Technical bulletin

SB-100-SB Sea valves

Products: SB-100-SB, SB-100-SA, DB-100-SB and DB-100-SA
100mm Sea valves

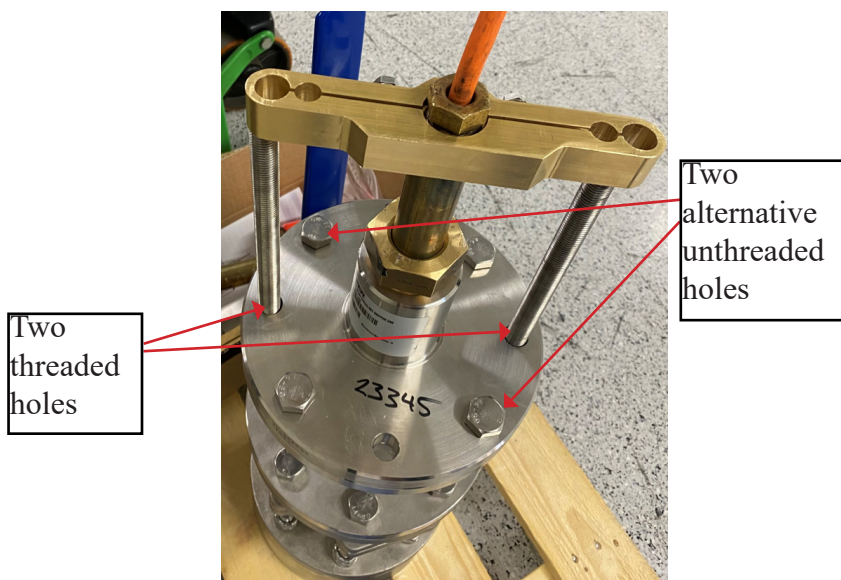
Issue: A number of Sea valves have been reported the two threaded holes in the intermediate element for installing 2 x thread bolts are not straight.
This can result in difficulties in entering the Clamping unit onto the bolts.

A number of sea valves are produced without threads in the “two threaded holes”.

This to enable easy installation and movement of the clamping unit.

Do not use high force Bending the bolts to install the Clamping unit.
The threaded bolts can be mounted onto any of the 6 unthreaded holes.
Remember 4 x Nuts M16 and 2 x Spring washer M16 on each bolt.

The threaded bolts can then be mounted onto any of the unthreaded holes.

Remember 4 x Nuts M16 and 2 x Spring washer M16 on each bolt.
